DATE: 28 October 2019
SUBJECT: Airway W37 Waypoint Issue
Impacted: A350 / A380 Customers Flying in Northern China
Cycles: 1912 – Effective Date 7 November 2019

SUMMARY

A change to one airway (W37) in AIRAC cycle 1911 has highlighted a software issue in A380/A350 FMS leading to repetitive resets during flight if the flight plan has a specific portion of the airway.

Waypoints Added in W37 for Cycle 1911

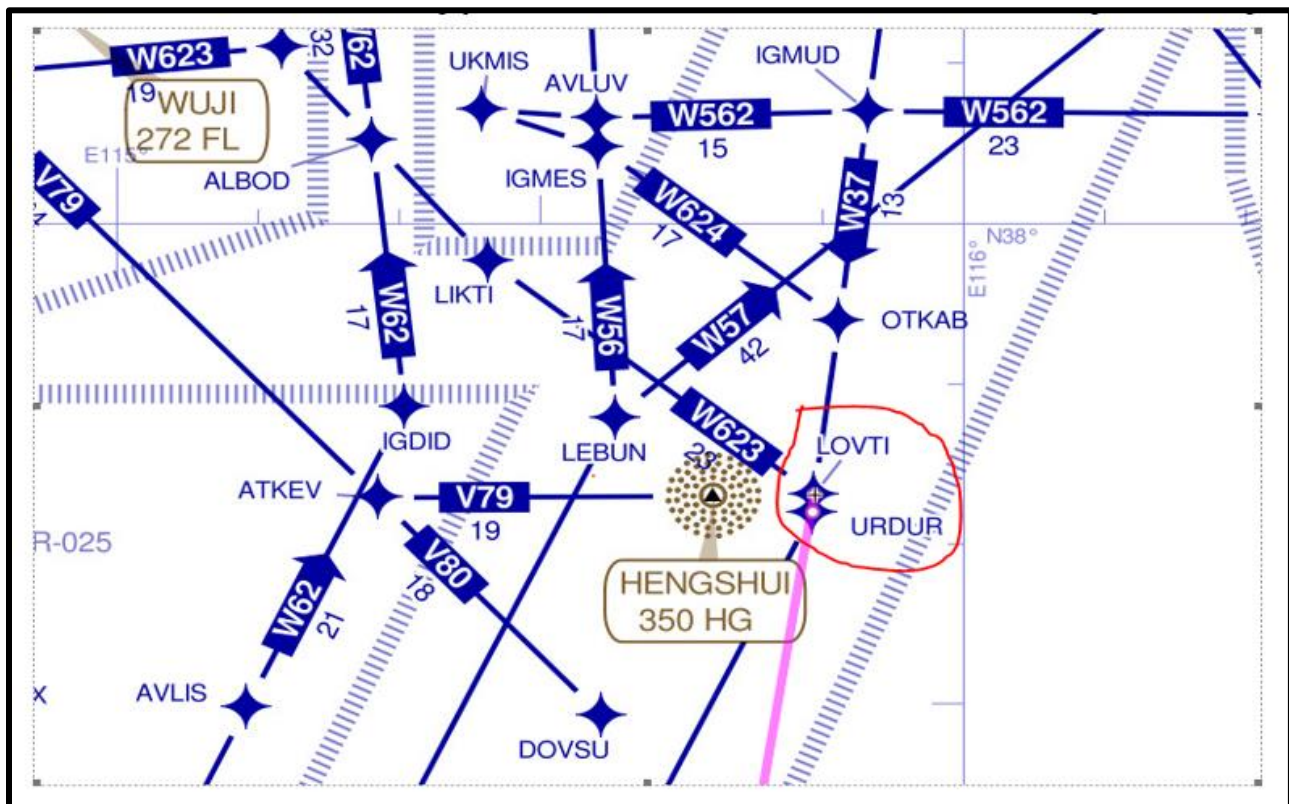
Honeywell received reports about repetitive FMS resets from A380 and A350 operators. Honeywell has identified the root cause of the issue which is triggered by a specific configuration of waypoints in Airway W37. The problem started to appear after several waypoints were added to Airway W37 that were very close in proximity to each other (distance from LOVTI to URDUR is 1.06 NM). Please see below.

Addition of waypoints in
AIRAC cycle 1911 in W37

LOVTI = Intersection of Several Airways

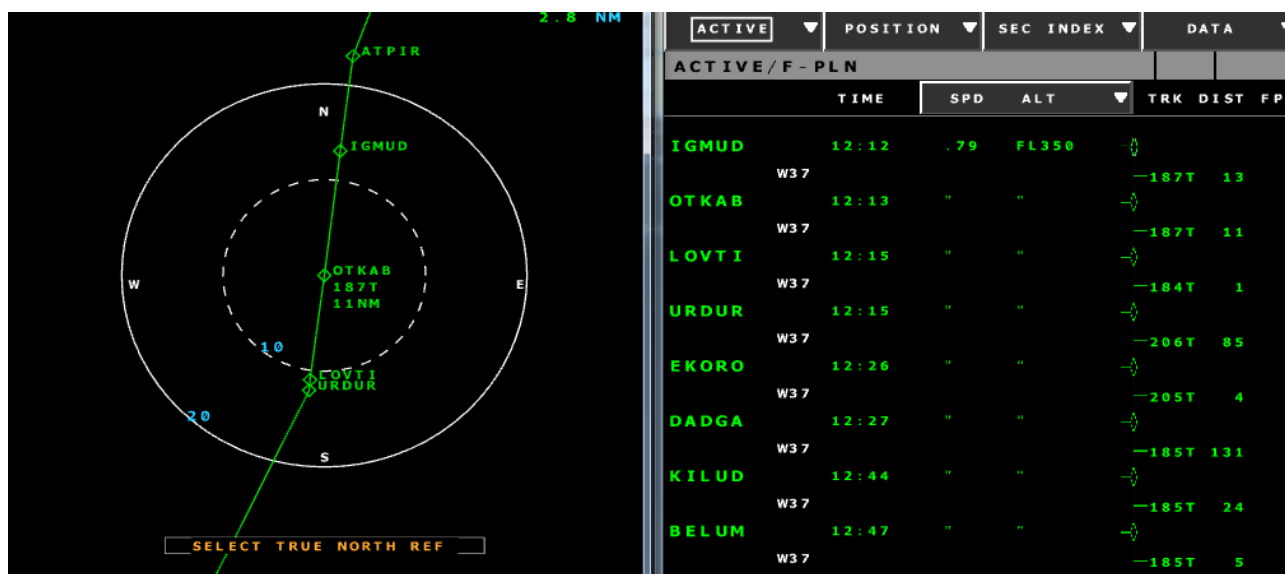
Interim solution is required: **Honeywell will remove waypoint URDUR from Airway W37 starting in cycle 1912.**

Before Airway W37 Change

After Airway W37 Change

Honeywell will implement a Navigation database modification which removes waypoint URDUR in Airway W37 to prevent occurrence of this reset.
